Submittal #238219-002.0 238219 - Fan Coil Units

Project: NCD23106.01 - Jenkins_SPCC Aseptic Training
Monroe, North Carolina USA

Fan Coil Units -FCU-4 - Product Data & Shop Dwgs

SIDE VIEW
(ALL SIDES IDENTICAL)

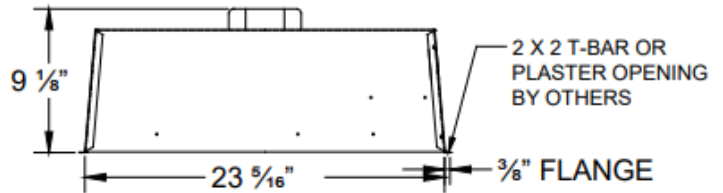
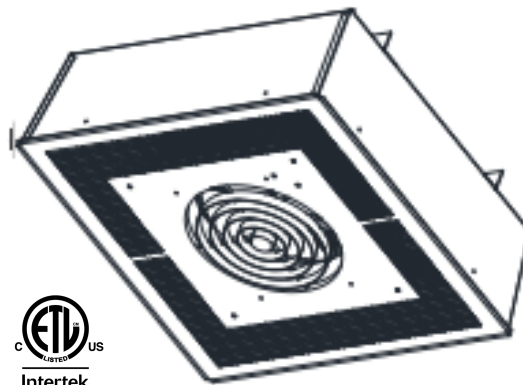
Coordinate KW with Electrical Contractor
